Arboricultural Impact Assessment

Dark Lane

Almondbury

Architect representation of development in relation to tree T10

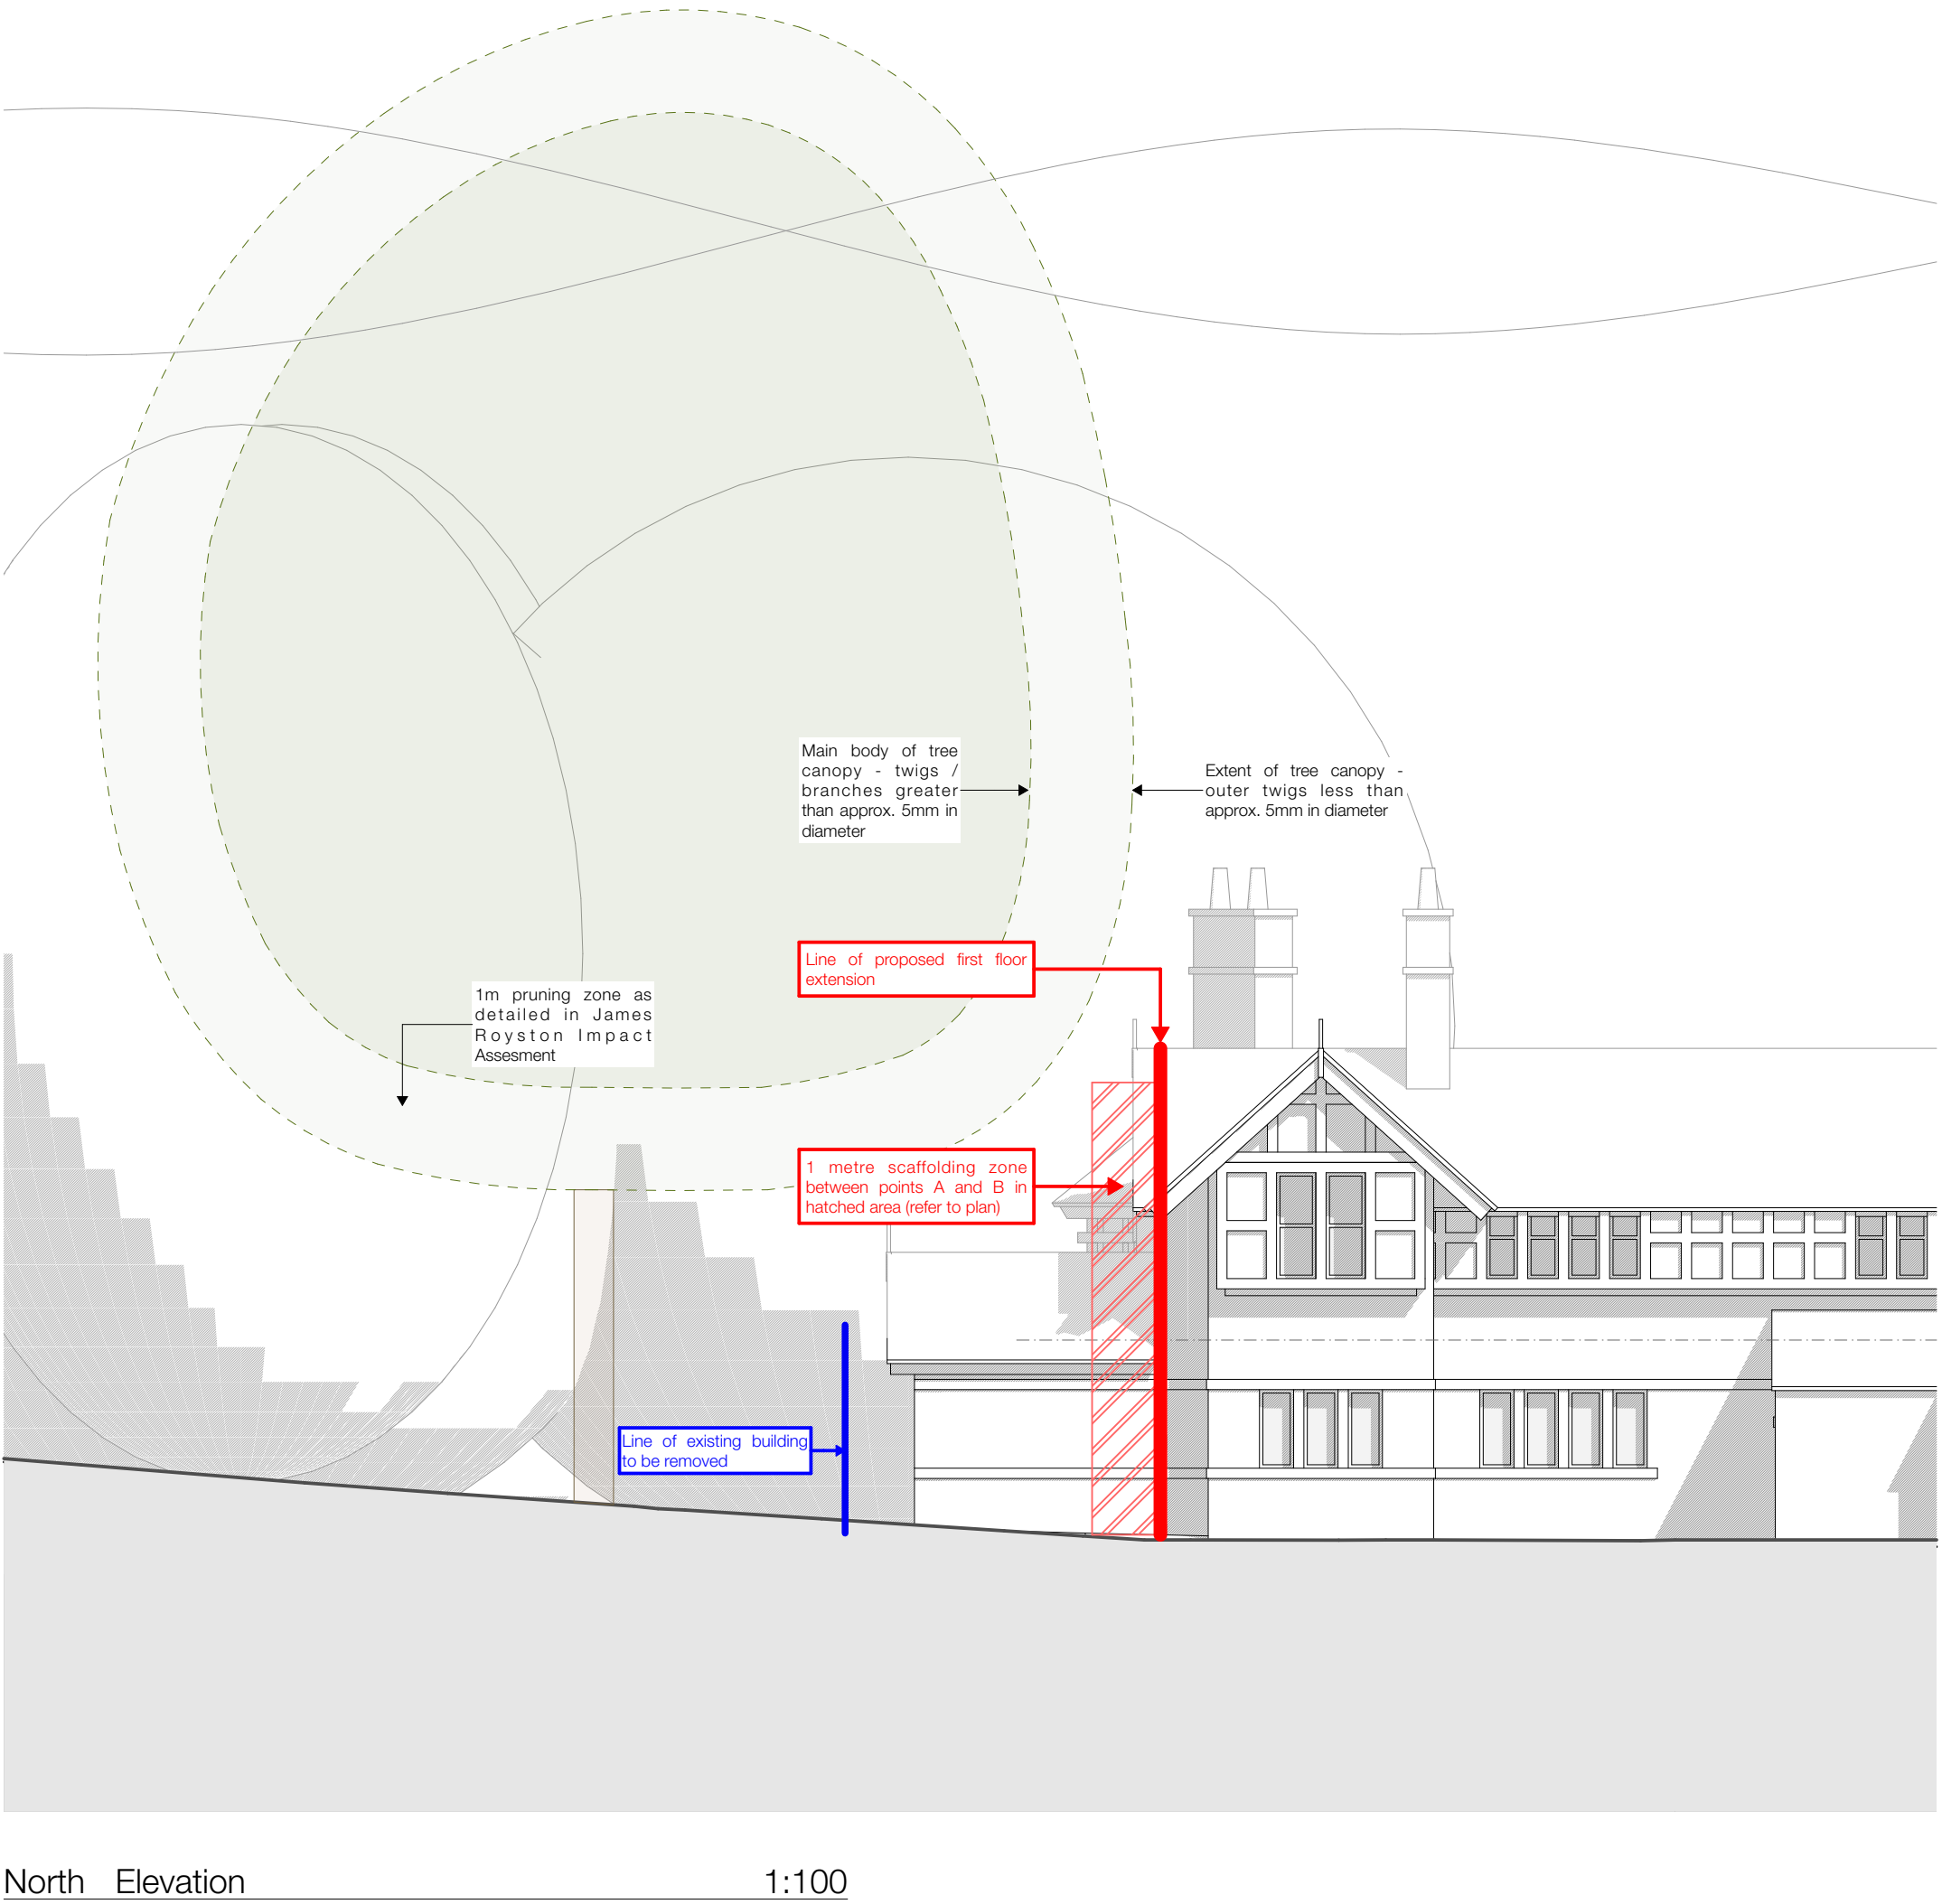
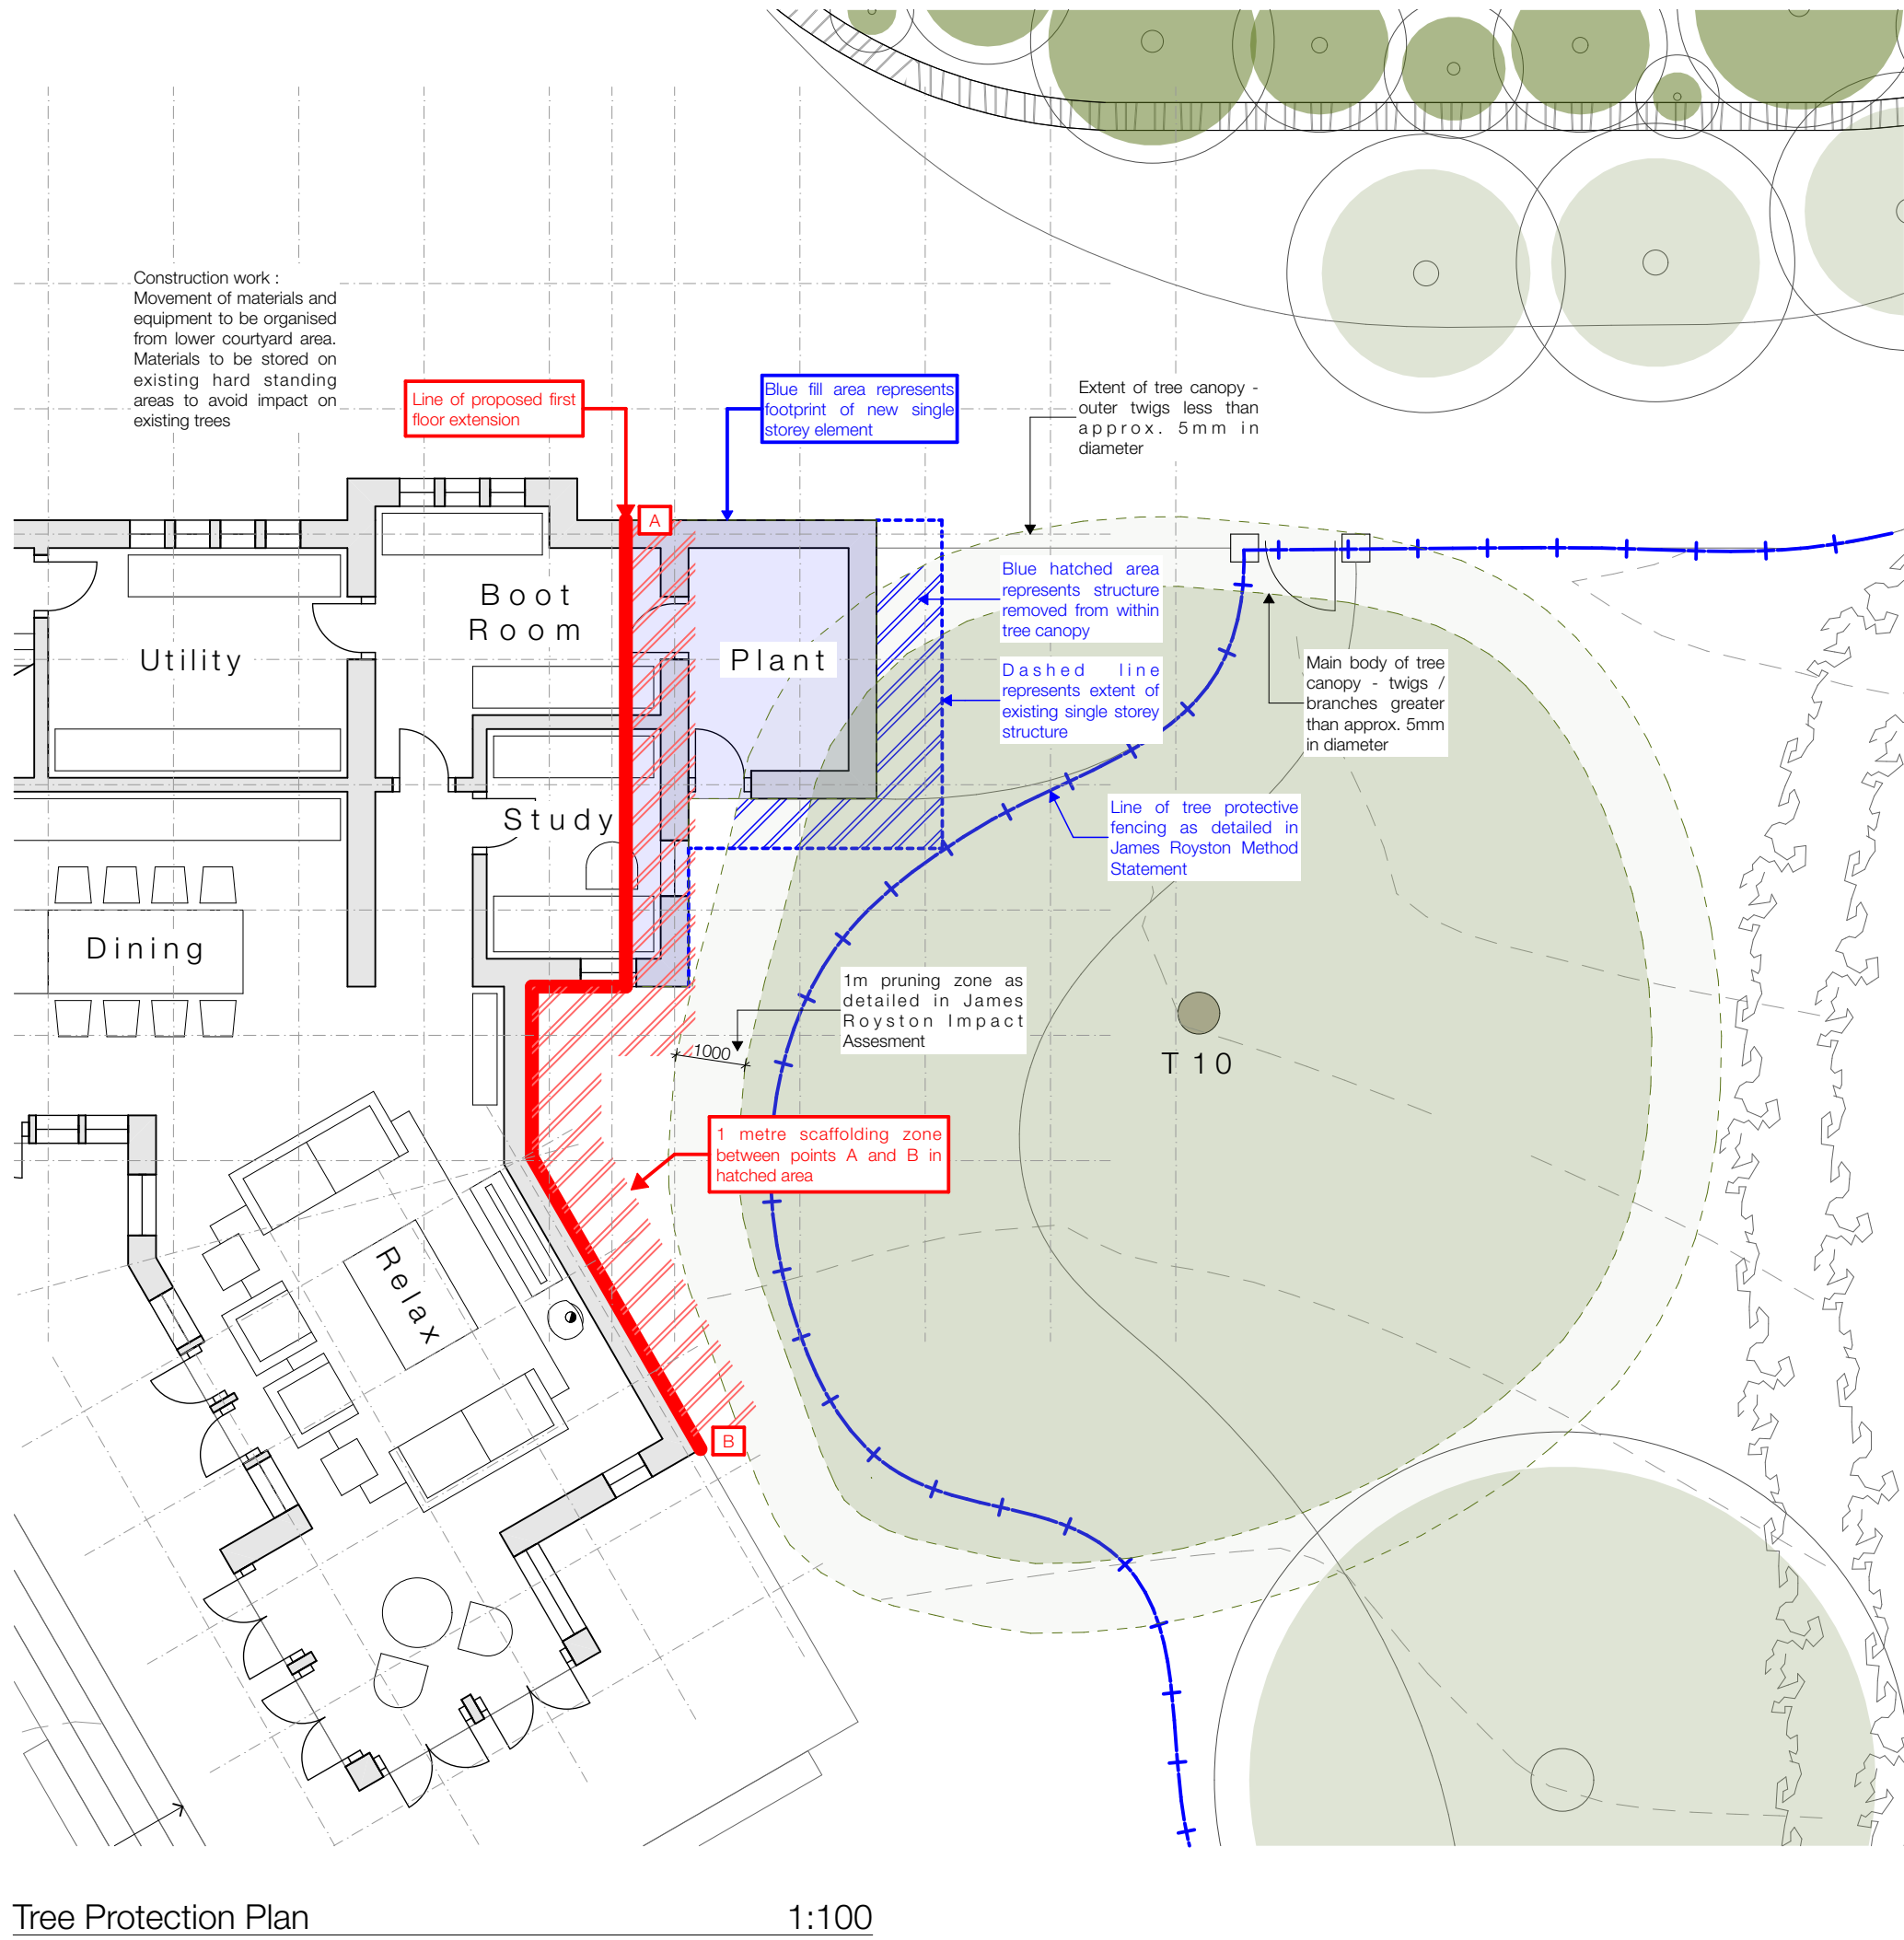
The council responded to 200901b/MS and states, *“Looking at the current layout plans online (revision D); located on the ground floor is a study, above that on the first floor is an area labelled ‘steam’. This first floor ‘steam’ part of the structure sits within the crown spread of the protected tree, as shown on the arb method statement plan. While the plan supporting the method statement only shows the ground floor layout, it does clearly depict the crown spread shown as a green line, passing through the edge of study area. Hence through the first floor structure above the study.”*

With reference to method statement Ref 200901b/MS the council goes on to state, *“There are no details in the impact assessment or method statement about how the layout has been changed or how the first floor can be facilitated within the crown area of the adjacent protected tree. It only sets out that the proposal is now possible with a 2m clearance using only secateurs, with no description about how a corner wedge of the building, with then a 2 m clearance as well, can be cut into this tree while avoiding adverse impact, secateurs or not.”*

The layout as shown in method statement Ref 200901d/MS (which is the subject of this impact assessment) has been changed so that there are no first floor structures within the canopy spread of T10. No pruning would be required to facilitate construction of this layout. The ground floor study is in the same location as existing structures and the first floor steam room is located further away from tree T10 than the ground floor study so that it will be entirely outside the canopy of that tree. Method statement Ref 200901d/MS includes a depiction of both the ground floor and the first floor layout so that this can be clearly seen.

The initial method statement method statement Ref 200901/MS showed a very minor incursion into the canopy of tree T10 by the part of the development labelled 'master bedroom'. In response to local authority feedback, the layout was changed to that as shown in method statement Ref 200901b/MS so that this section of the development would be located entirely outside the canopy of tree T10. Further local authority feedback has asked for the first floor steam room to be located outside the canopy of tree T10. As is shown in method statement Ref 200901d/MS, the layout has been changed so that the steam room (and all first floor structures) are located outside the canopy of tree T10.

No pruning is required to facilitate this development, and none is recommended by this consultant – all first floor structures located near tree T10 are located outside the tree canopy and all ground floor structures are in the same location as existing single storey structures. However, past feedback from the local authority states that a 2m clearance between new structures and existing tree canopy should be created. The amount and type of pruning that this would require is so minor that it can be achieved with the use of secateurs – only a very small section of very small diameter twigs would need to be removed to achieve the 2m clearance as requested by the local authority. There would be no wedge cut into the tree, the pruning as requested by the local authority would be extremely minor and would have no impact on the condition, the aesthetic, or the amenity value of the tree whatsoever.

To put it another way - a drawing has been produced by the architect using 3d CAD software which shows the top and side view of the development in relation to tree T10, this drawing is included at the appendix for reference. This shows two canopy outlines – the larger outline is the full extent of the existing canopy, and the smaller outline is an indication of the parts of the canopy which contain twigs of larger than 5mm diameter. The smaller canopy outline is NOT an indication that the tree is going to be pruned back to this line, it is merely an indication as to where some of the twigs in the canopy become larger than 5mm in diameter.

The drawing clearly shows that no pruning is required to facilitate this development, and no pruning is therefore recommended by this consultant. However, to accommodate 2m clearance pruning between the development and the canopy of tree T10 as is requested by the local authority, some extremely minor pruning will be required. The type of pruning is of a similar type as is frequently approved by the local authority, but it is much less significant than that which would normally be applied for and approved. The pruning required to achieve 2m clearance between the tree canopy and the development will only involve the most minor of crown lifting to a very small part of the canopy.

The architect drawing also shows the several changes that have made to the layout as a result of feedback from the local authority.
